**Staff Report  
BOA-23921**

1546 South Harvard Avenue  
Tract Size: ±0.14 acres

<b>Project Name:</b>	16th & Harvard - ADU
<b>Date:</b>	7.18.2025
<b>Response By:</b>	Cody Rogers cDesign, LLC. PO Box 576 Mounds, OK 74047 918.809.6813 cdesignhomes@gmail.com

<b>Plan Corrections Summary:</b>	BLDR-210056-2025 (1546 S HARVARD AVE E Tulsa, OK 74112) Markup Summary #1
<b>Project Name:</b>	16th & Harvard - ADU
<b>Application Number:</b>	BLDR-210056-2025
<b>Plans Examiner:</b> Architectural	George Goza City of Tulsa - Development Services 175 East 2nd Street, Suite 450 Tulsa, OK 74103 918.576.5405 ggoza@cityoftulsa.org
<b>Plans Examiner:</b> WSD	James Henley City of Tulsa - Development Services 175 East 2nd Street, Suite 450 Tulsa, OK 74103 918.596.7344 jameshenley@cityoftulsa.org
<b>Plans Examiner:</b> Zoning	Danny Whiteman City of Tulsa - Development Services 175 East 2nd Street, Suite 450 Tulsa, OK 74103 918.596.9664 dwhiteman@cityoftulsa.org
<b>Corrections Summary:</b> Received Date	4.18.2025
<b>Corrections Summary:</b> Response Date	5.6.2025
<b>Response By:</b>	Cody Rogers cDesign, LLC. PO Box 576 Mounds, OK 74047 918.809.6813 cdesignhomes@gmail.com

**SHEET NUMBER**  
**SE.01**

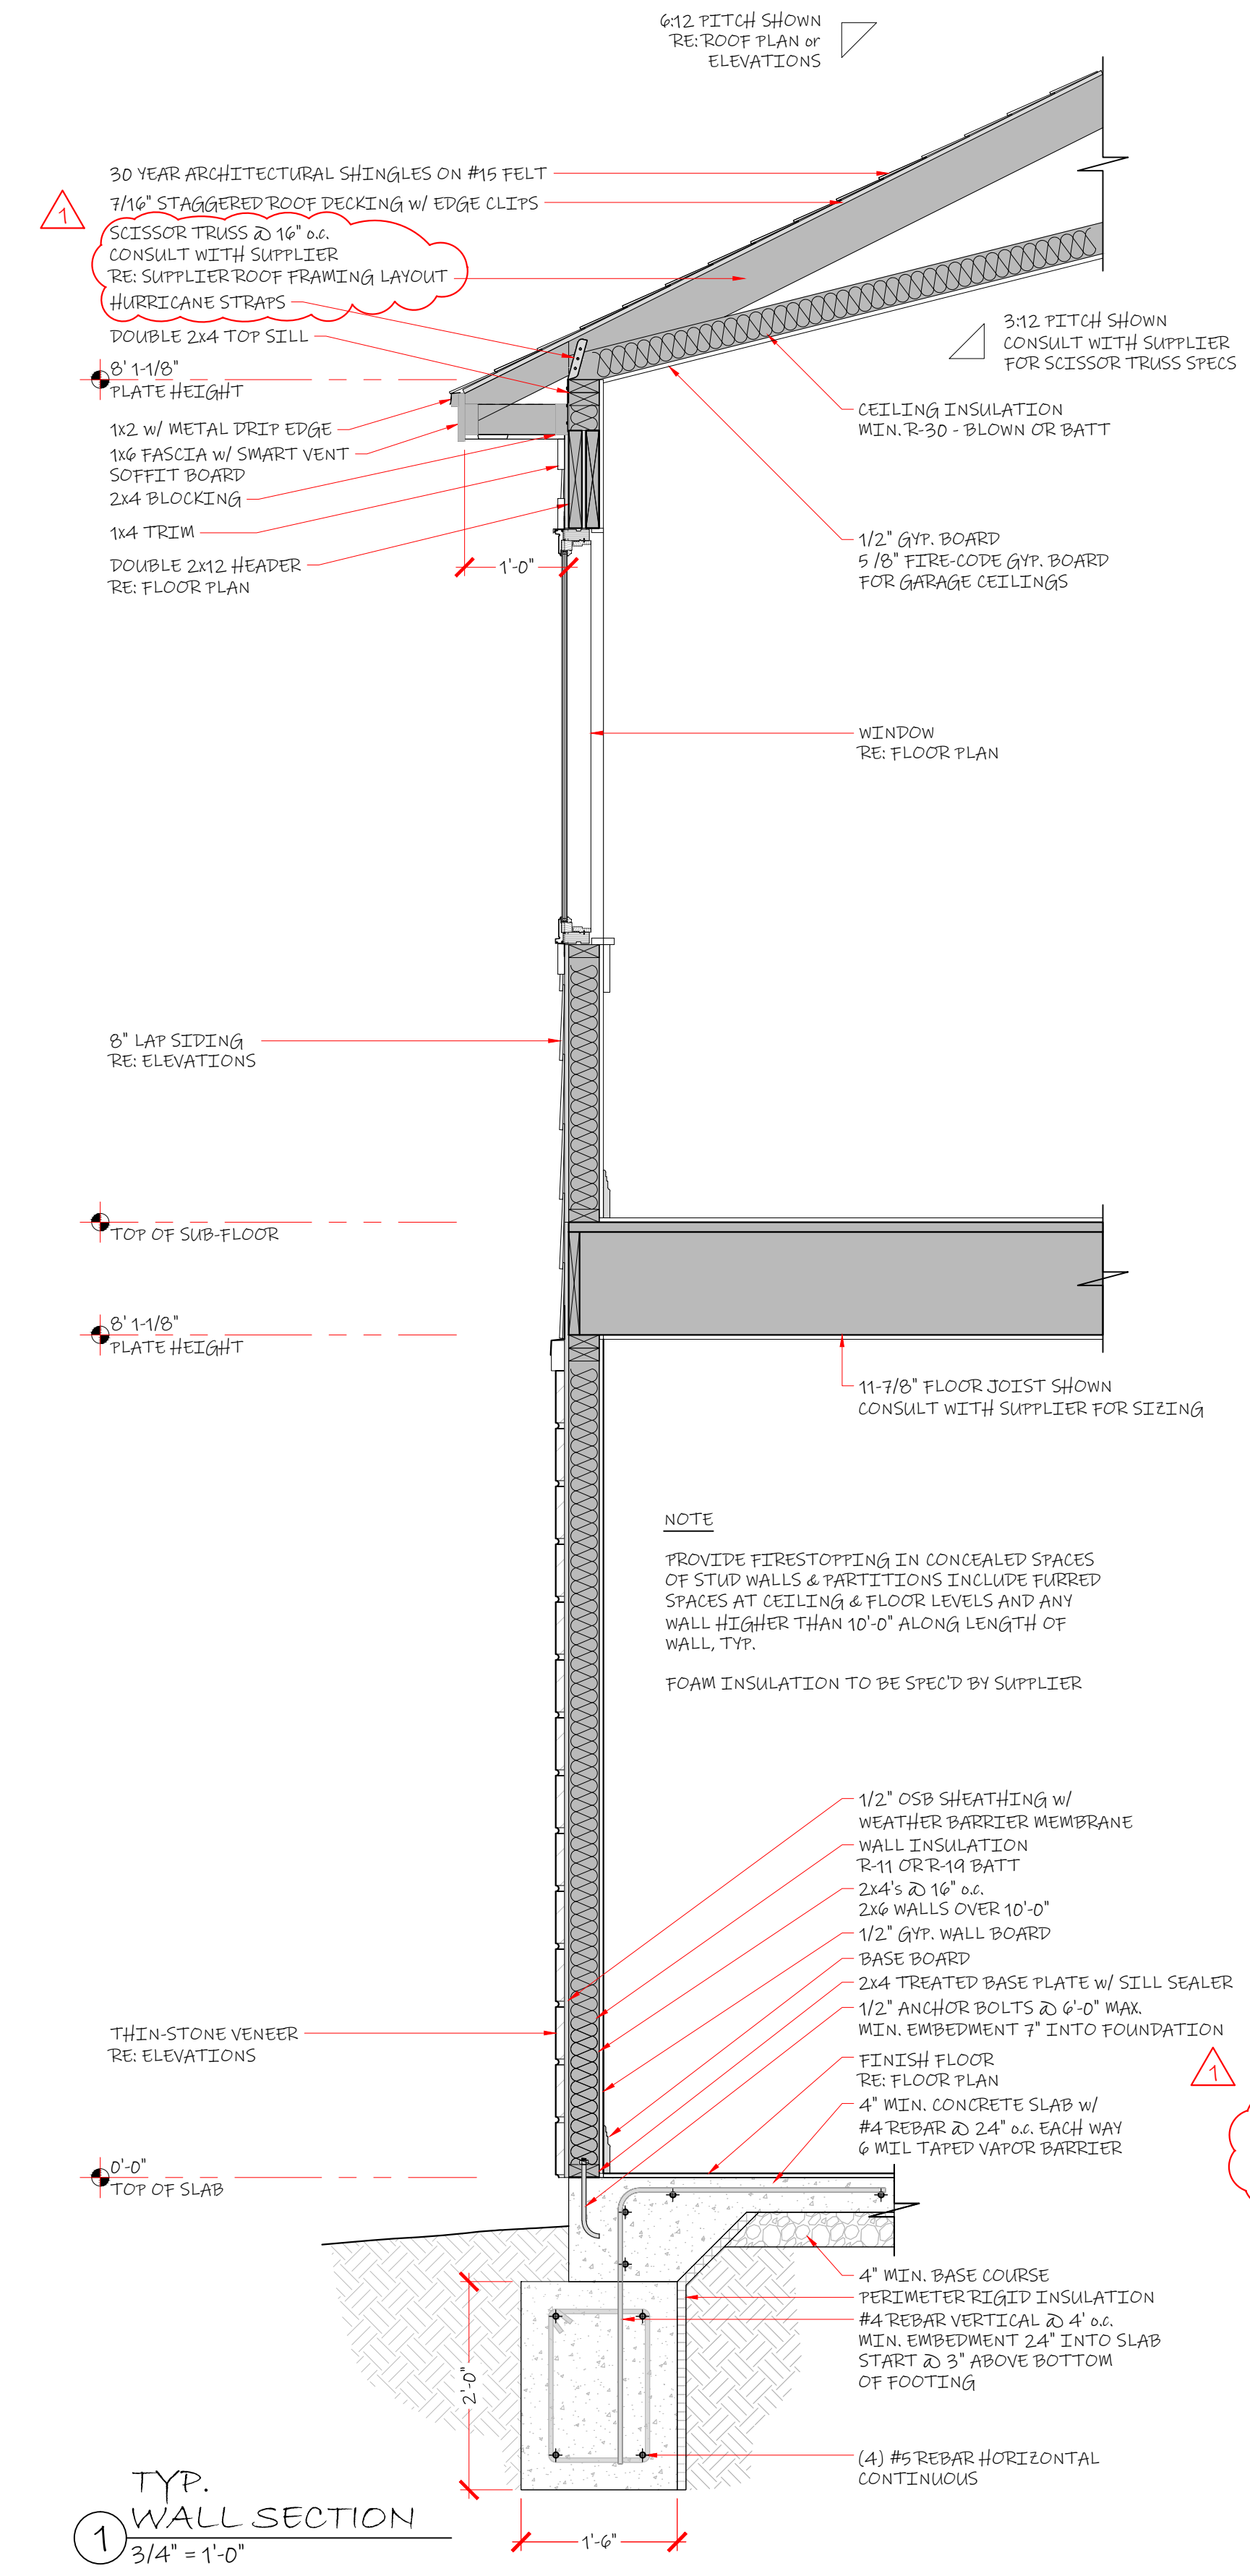
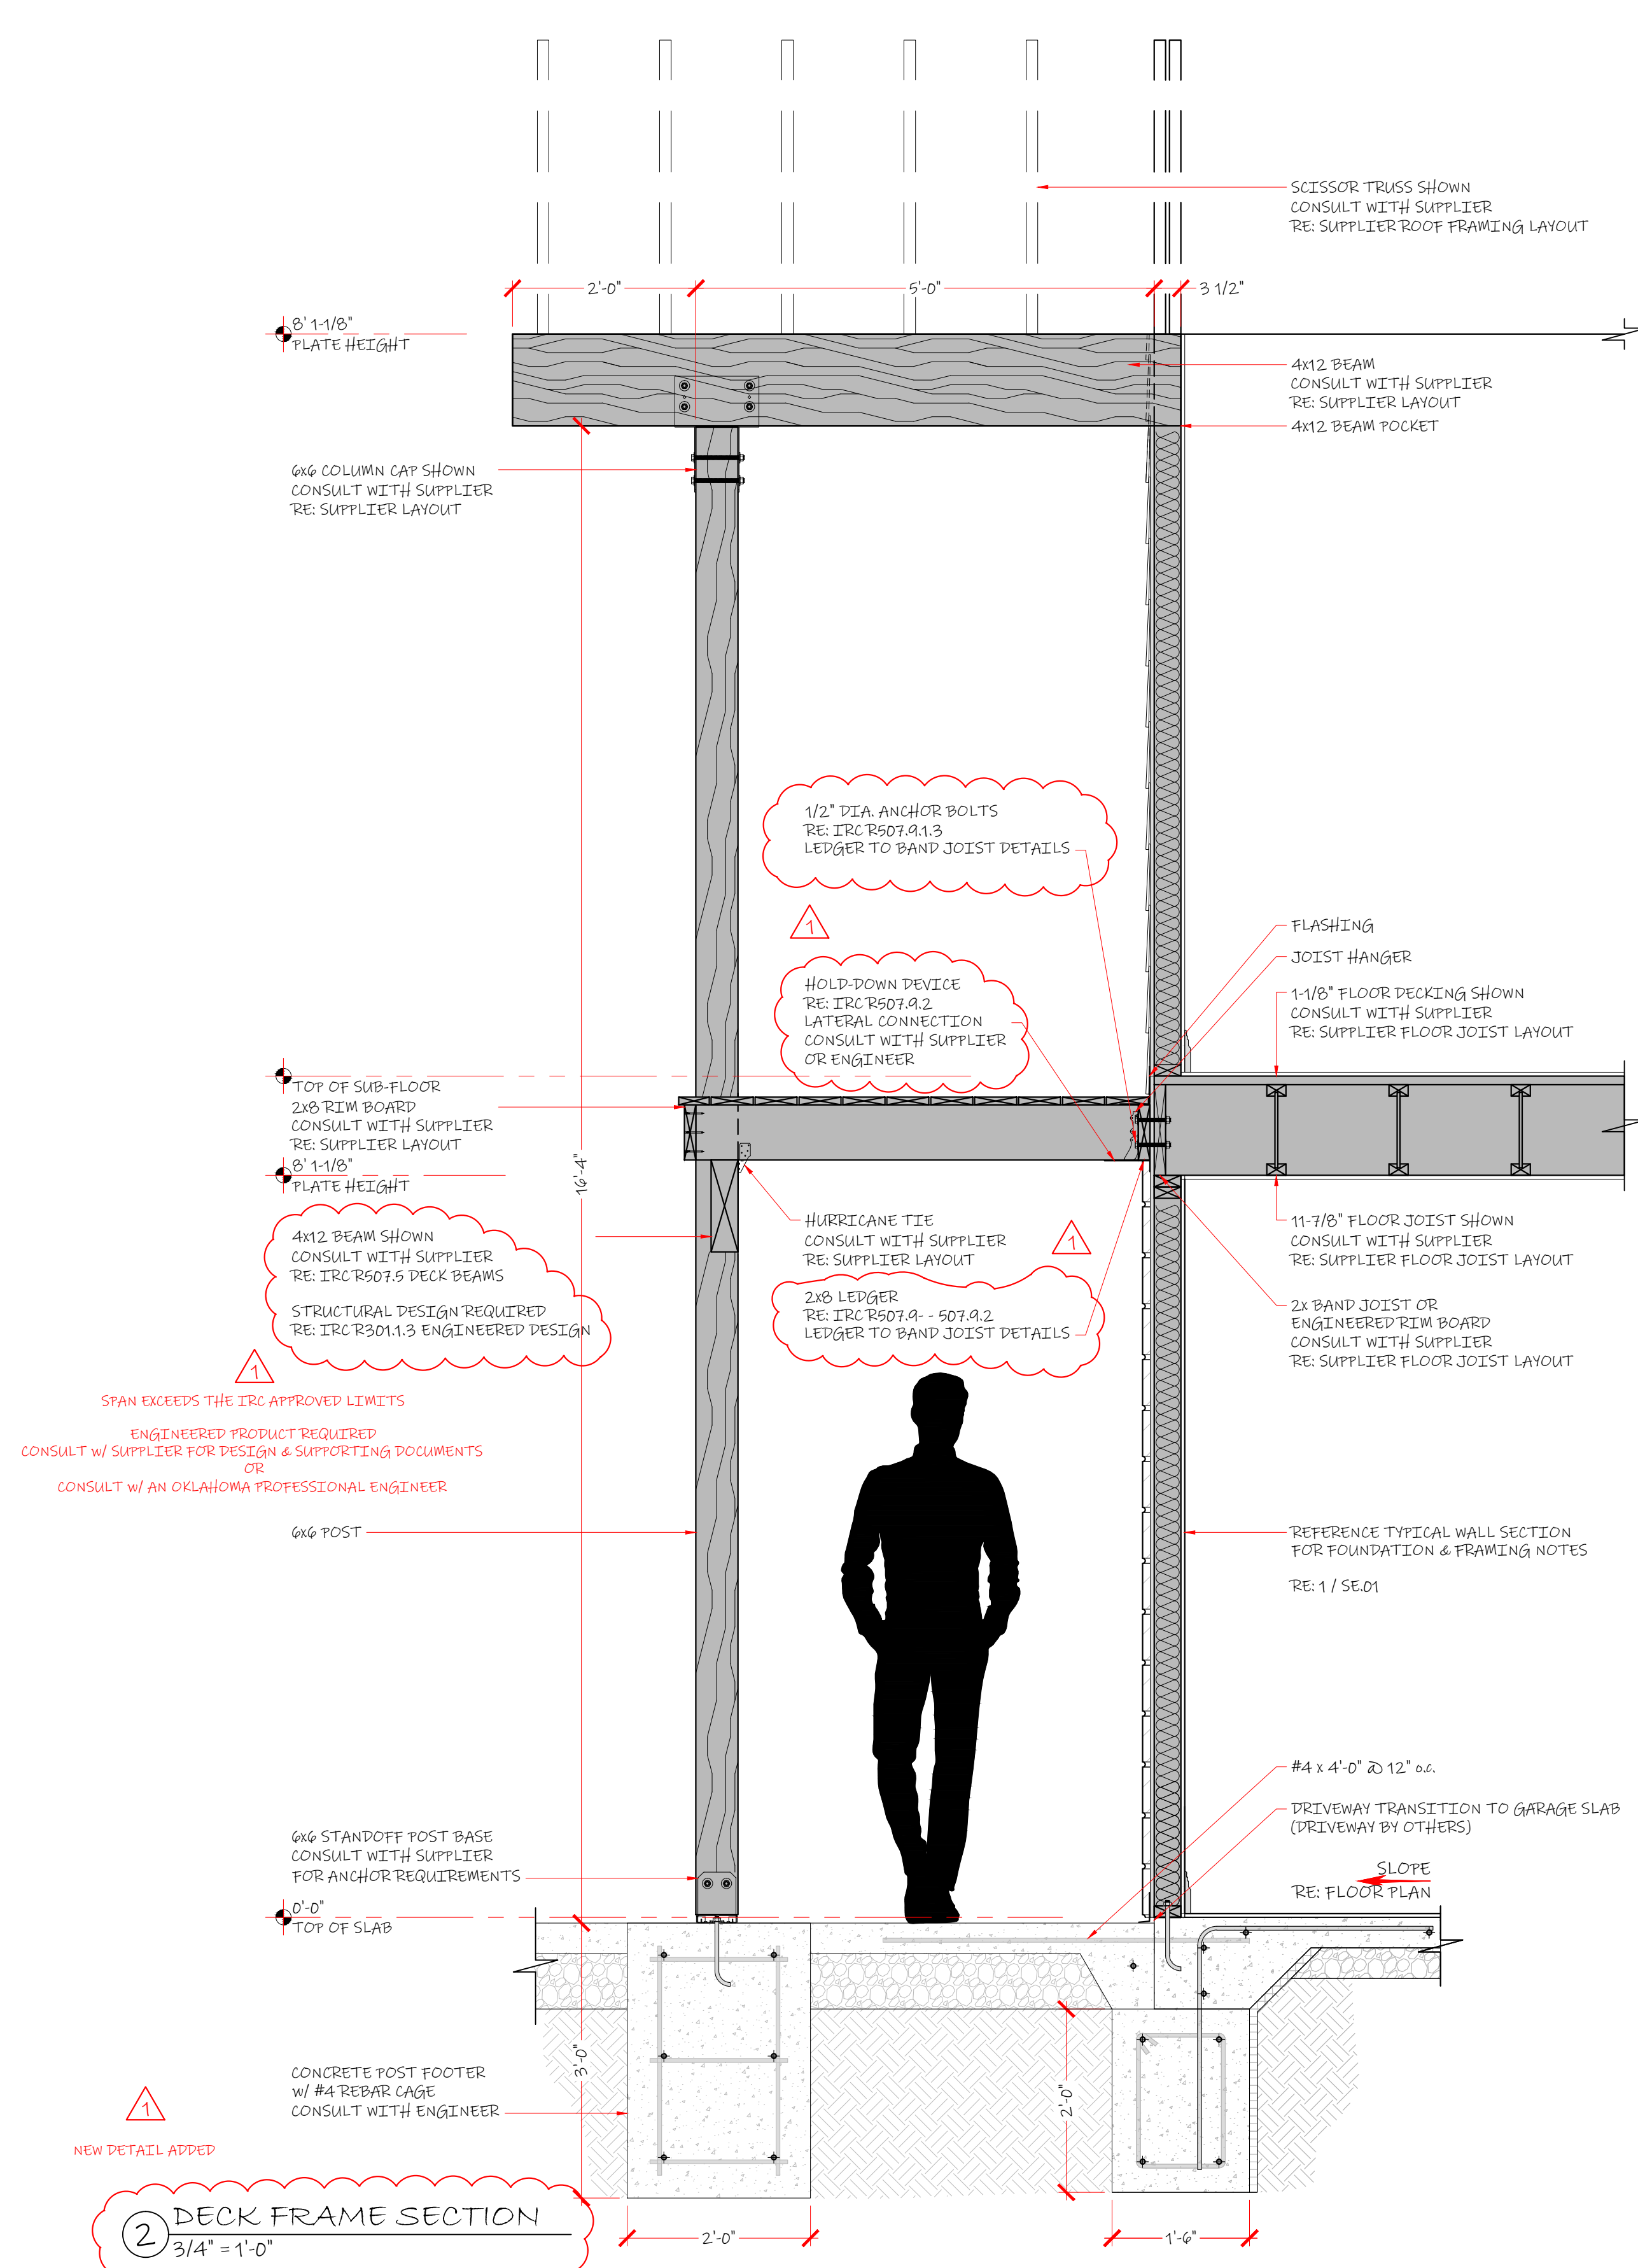
*R507.9- - 507.9.2 Vertical and lateral connections. Please review for a method to attach the deck to the structure and describe by detail and/or sufficient notes to adhere to section(s).*

*Table R803.1 Minimum thickness of lumber roof sheathing. For the use of 1/2-inch or equivalent roof decking please specify a truss spacing of 16-inches. If truss spacing will be 24-inches, please specify 5/8-inch or equivalent roof decking.*

Refer to new sheet SE.01 - Deck Frame Section. The vertical and lateral connections have been notated to reference the appropriate IRC sections.

Refer to new sheet SE.01 - Typical Wall Section. The truss spacing has been notated for 16" o.c.

① ROOF PLAN  
3/8" = 1'-0"

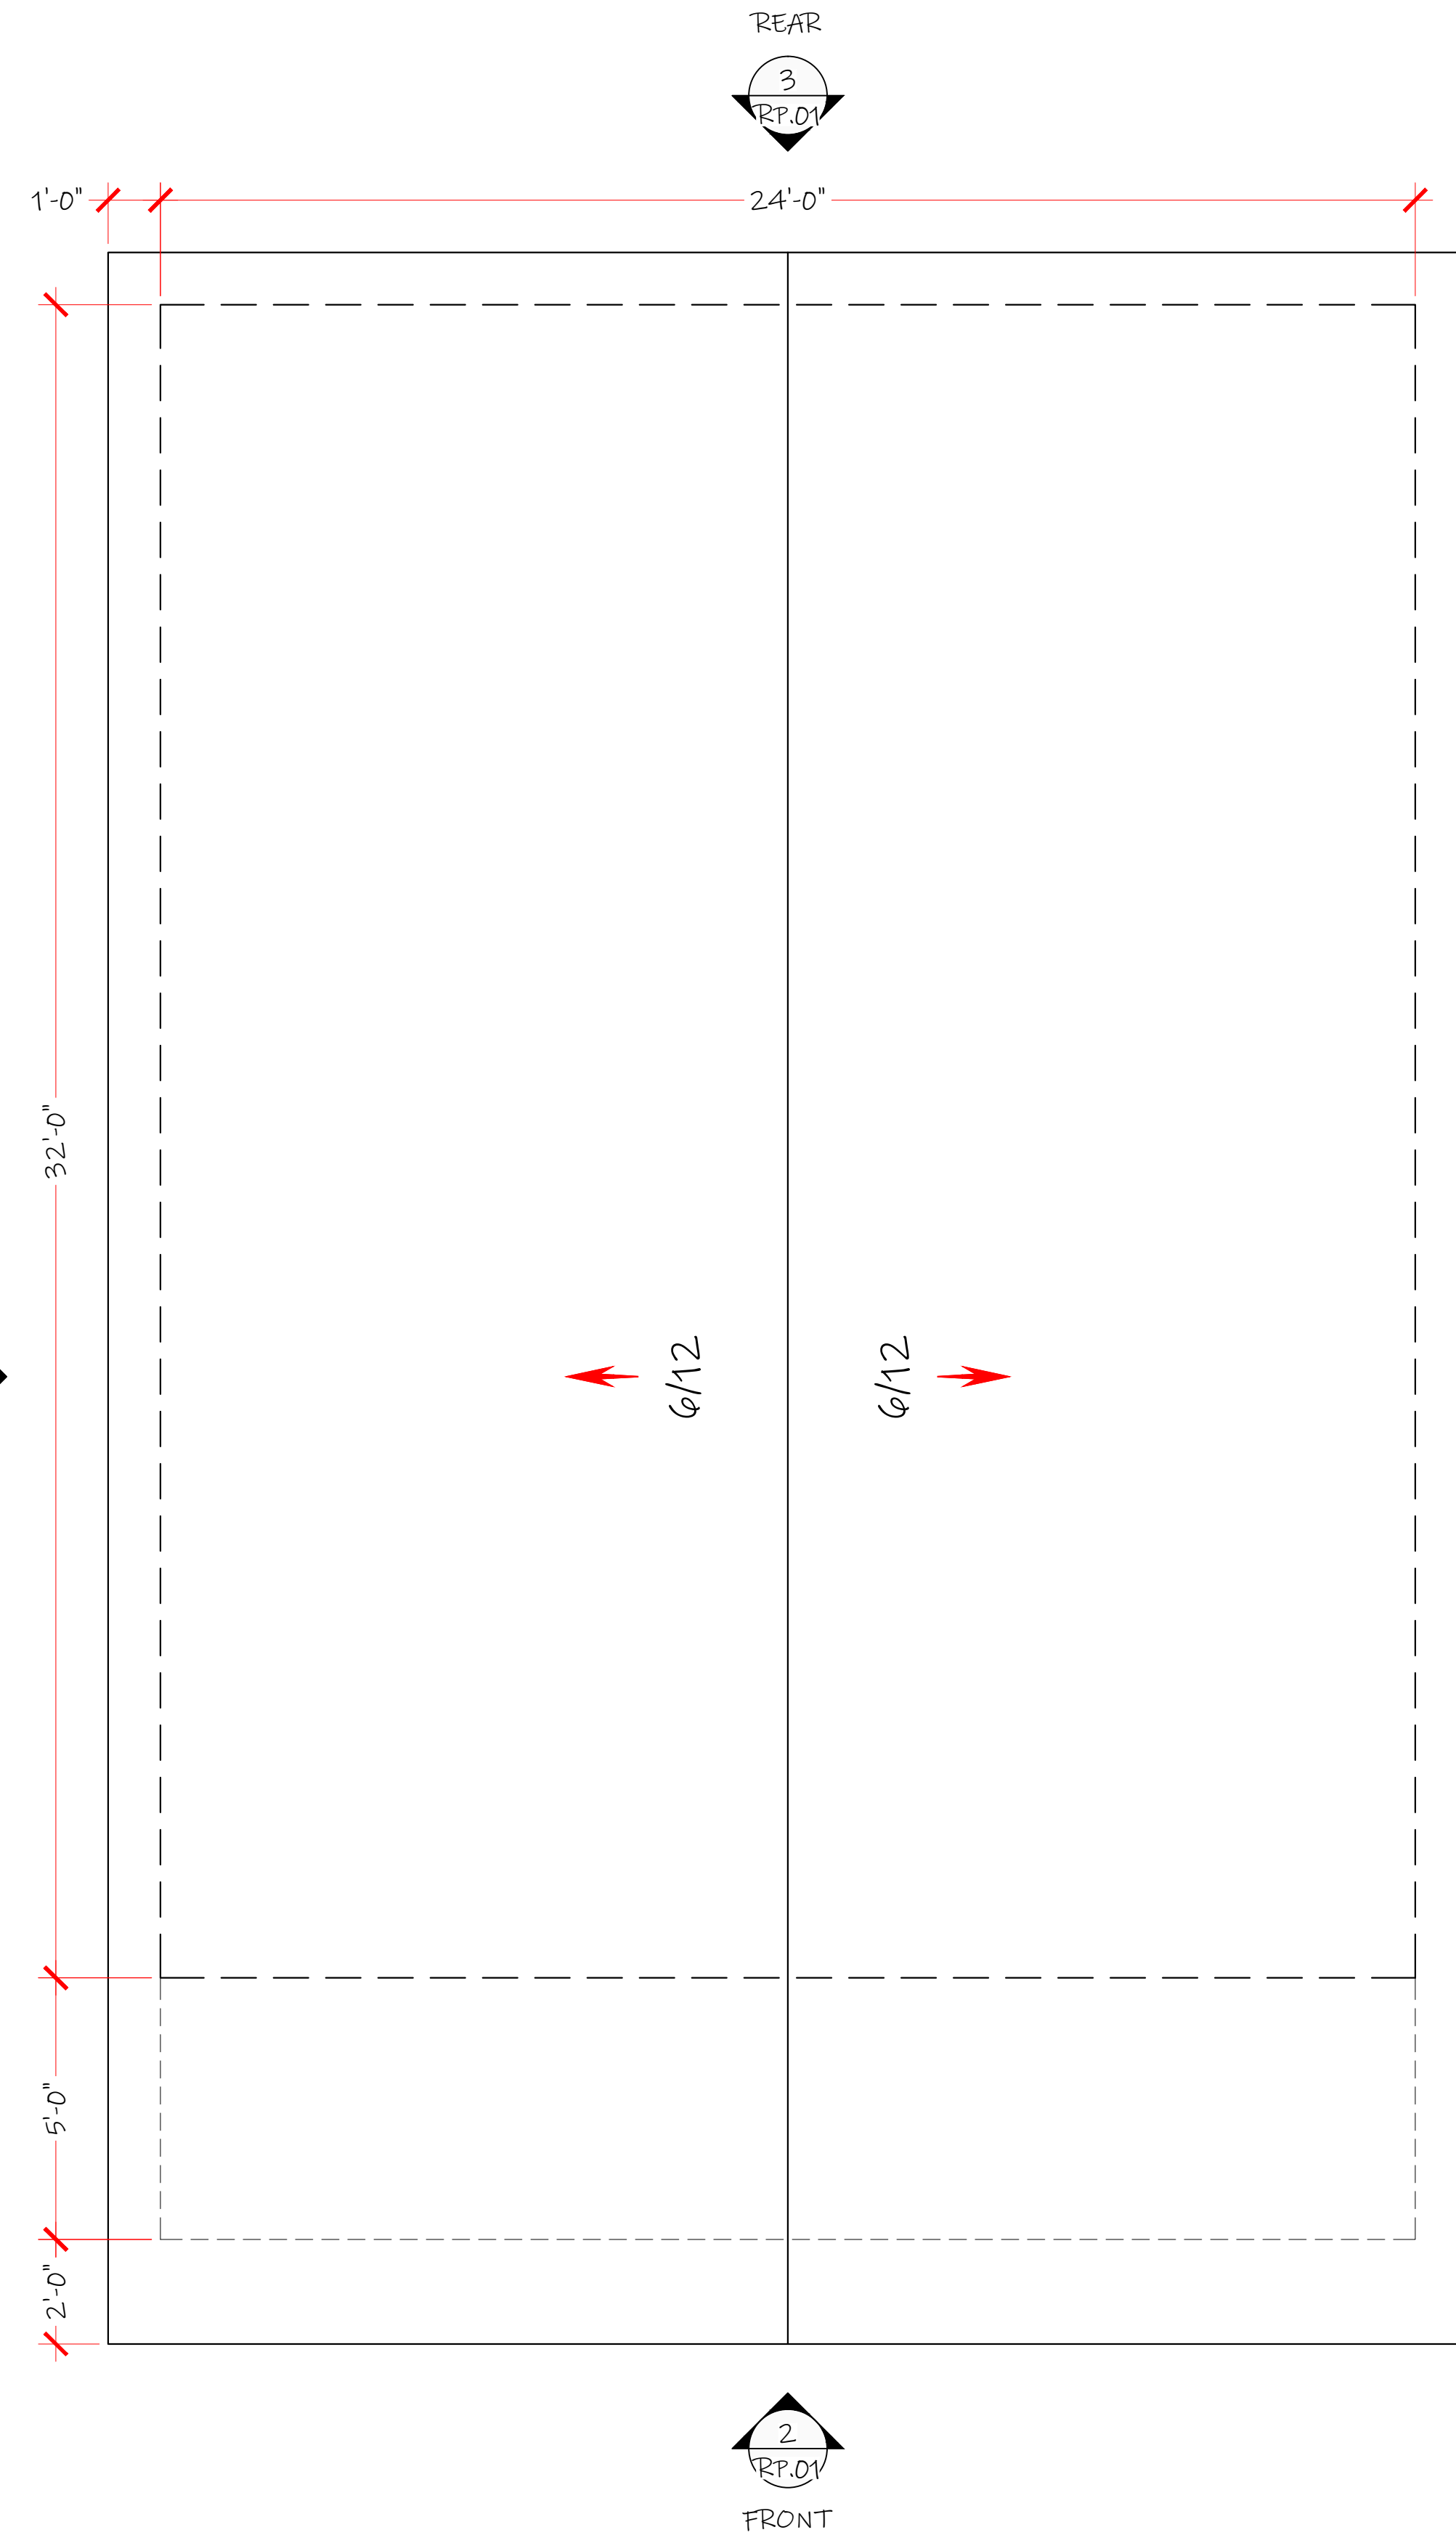
*The lot to the west of this lot is RS zoned. According to the table the base setback required is 10' from an RS zoned lot. According to the footnote, 2' of additional setback is required for each foot of building height above 15'. The proposed building height is 23' 11" which is 8' 11" above 15'. Therefore, 17' 10" needs to be added to the base setback of 10'. In summary, this building as proposed requires a 27' 10" setback from the west property line. Please revise plans accordingly.*

Refer to revised sheet SP.01 - Site Plan & revised sheet RP.01 - Roof Plan. The proposed building has been repositioned and now has a set back of 16'-11" from the lot to the West. The proposed building height of 23'-11" did not change. Variance Required
